Re: Petition No. 1527 Stevenson to Pootatuck Rebuild Project

Response to CSC-02 Interrogatories dated September 23, 2022
Set 02 - Questions 29-32

Stevenson to Pootatuck Rebuild Project

Mapsheet 8 of 14

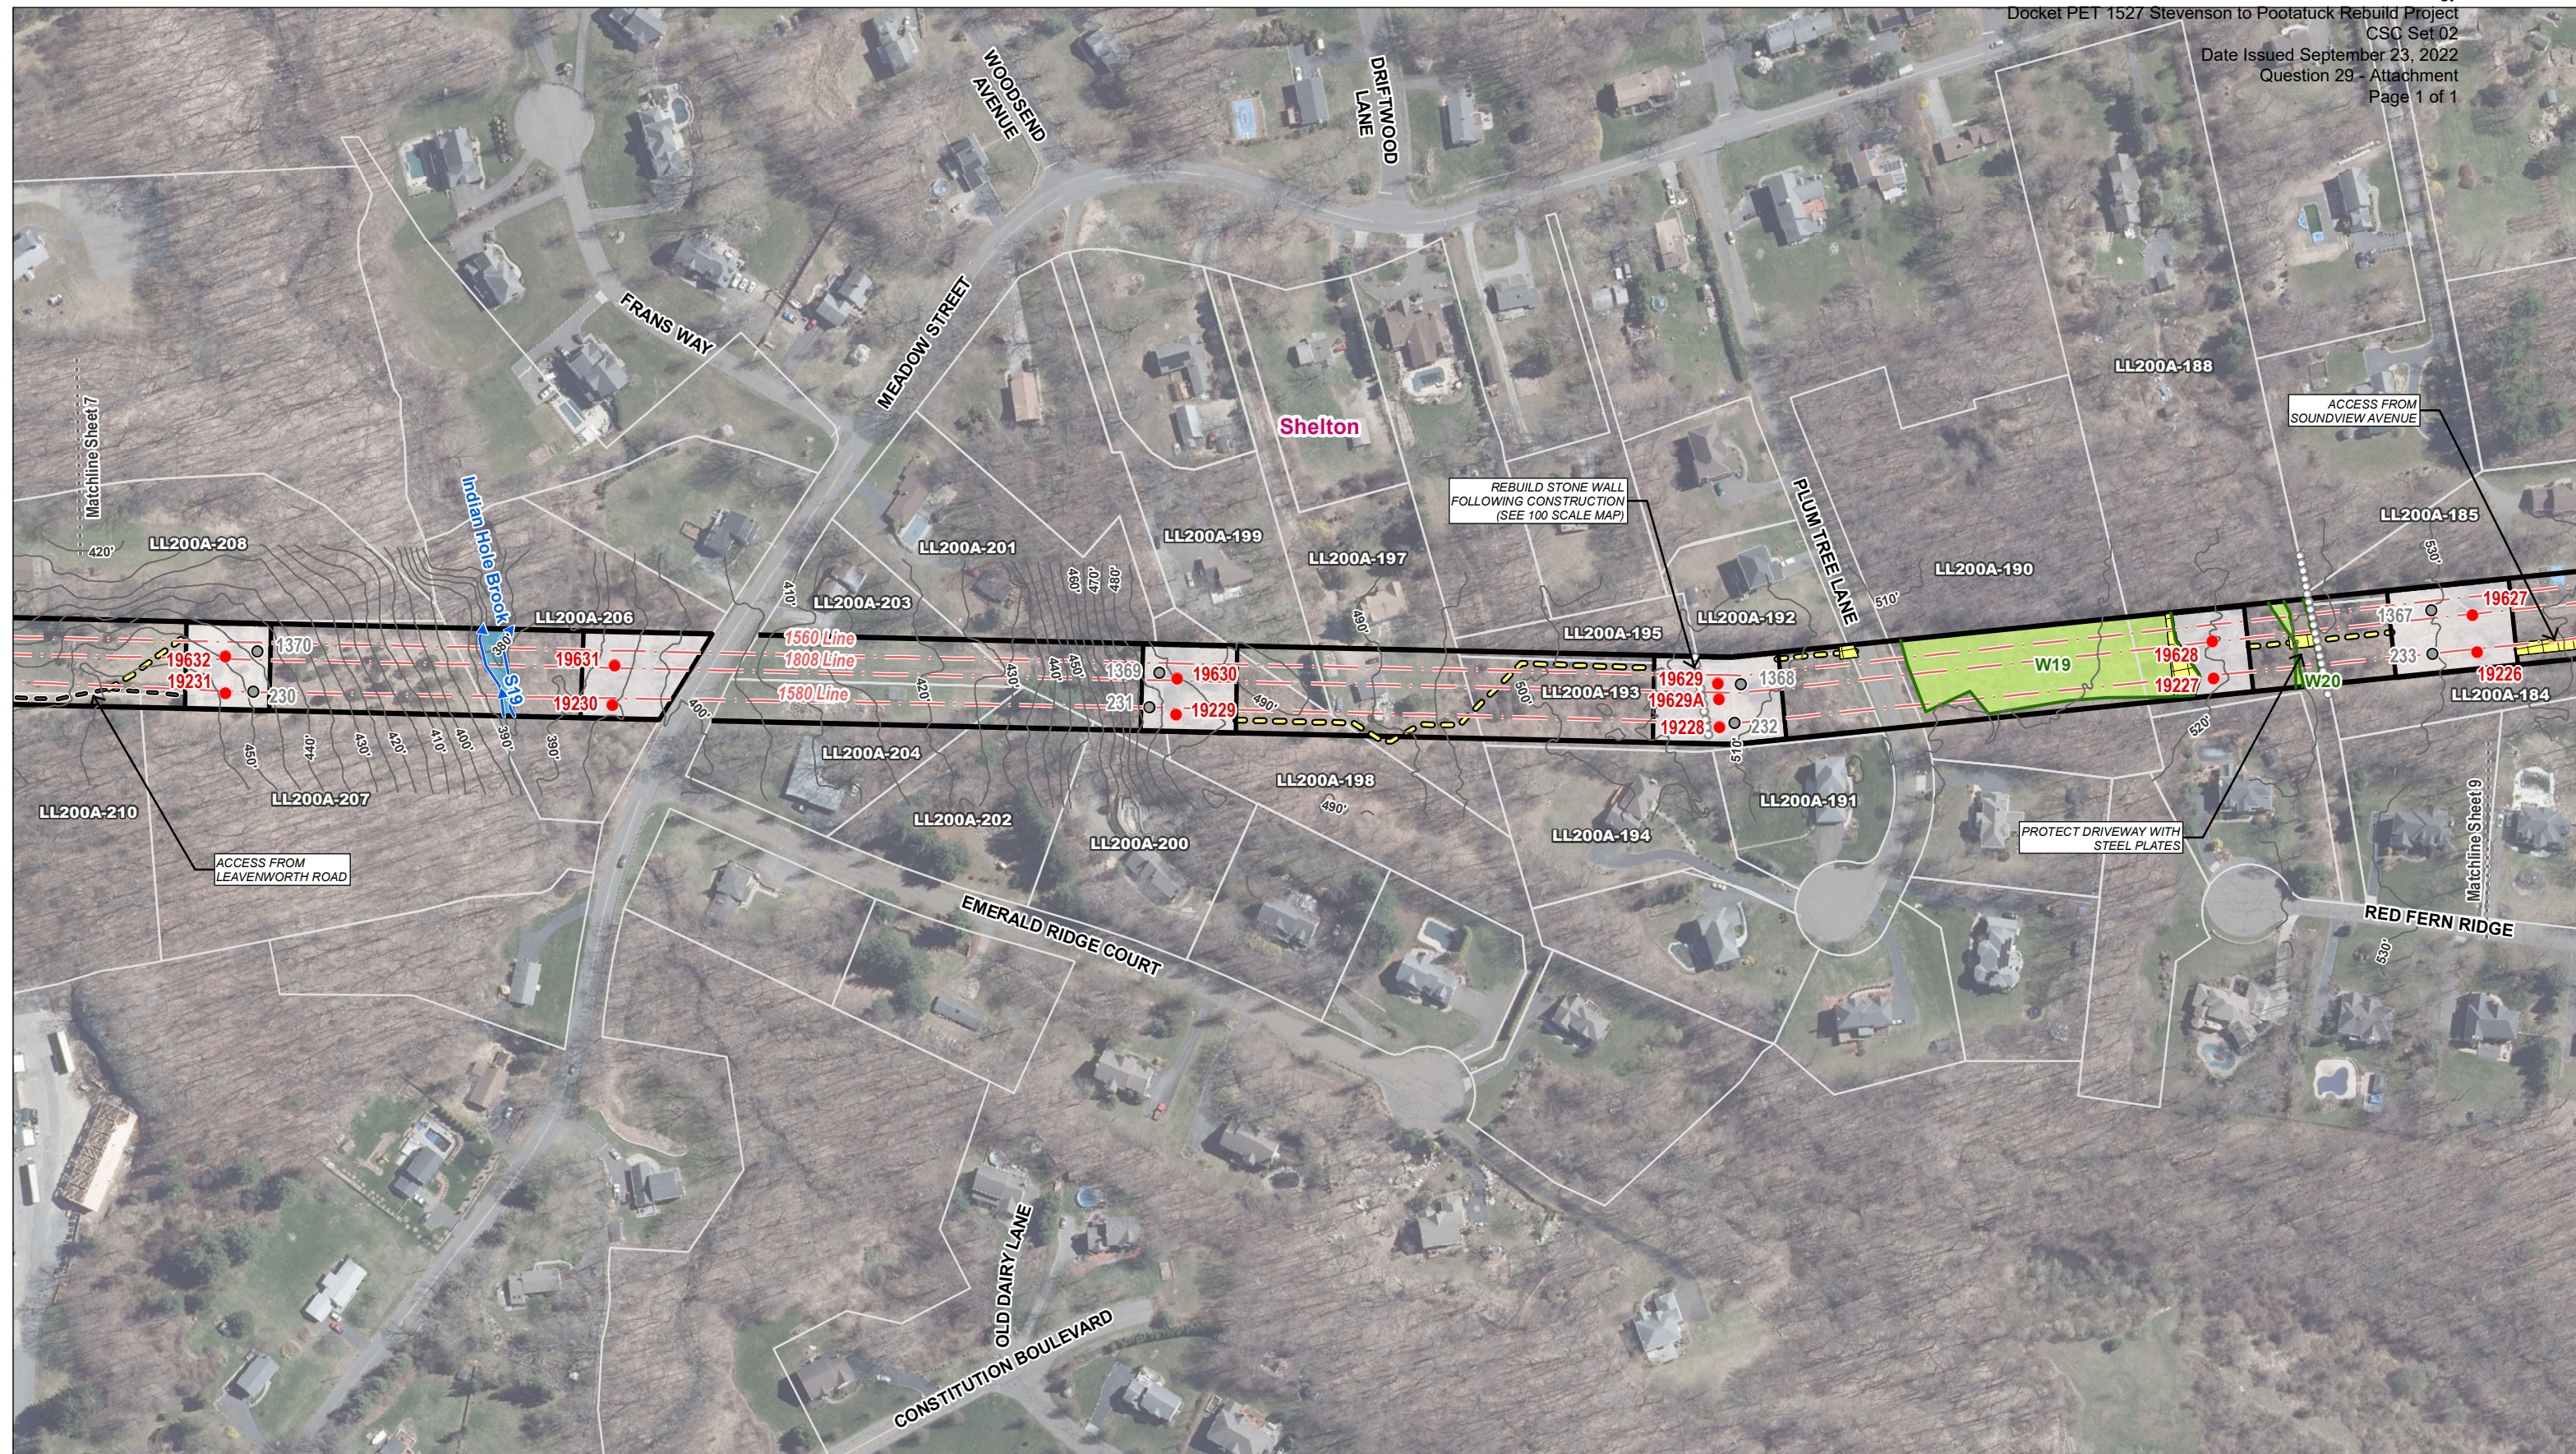
- a. What is the expected visibility of the proposed Structures 19254, 19655, and 19655A to the abutting residences?
- b. What would be the expected visibility for abutting residences if Structures 19254, 19655, and 19655A were relocated to the pull pad location north of Thoreau Drive?
- c. What would be the expected visibility for abutting residences if Structures 19254, 19655, and 19655A were relocated to the Wetland 7 area south of Thoreau Drive?
- d. Provide a revised map sheet that depicts the relocation of Structures 19230 and 19631 approximately 10 to 20 feet to the north and specify the associated structure height increase. Confirm that Eversource will relocate these two structures as part of this project.

Question: 31

Referring to Map Sheet 8, provide the span lengths between structure groups 19627-19226 and 19629-19629A-19228.

Describe the feasibility of the relocation of Structures 19627 and 19226 to the northwest to the edge of the proposed gravel work pad in order to eliminate midspan Structures 19628 and 19227.

- d. Eversource proposes to relocate structures 19230 and 19631 15 feet to the north. No structure height increase is proposed as part of the relocation. See the attached revised Mapsheet 8 of 14 (dated October 2022).

Span lengths between structure groups 19627-19226 and 19628-19227 are approximately 335 feet.

Span lengths between structure groups 19628-19227 and 19629-19629A-19228 are approximately 631feet.

Based on the span lengths set out in the response to Question 31, if proposed midspan Structures 19628 and 19227 were eliminated, the resulting span length would be approximately 966 feet (335 feet plus 631 feet). Relocating Structures 19627 and 19226 to the northern edge of the proposed gravel work pad would only shorten the span approximately 50 feet, resulting in a span length of approximately 916 feet. A span of this length would lead to a violation of Eversource's conductor blowout clearance standards in this corridor.
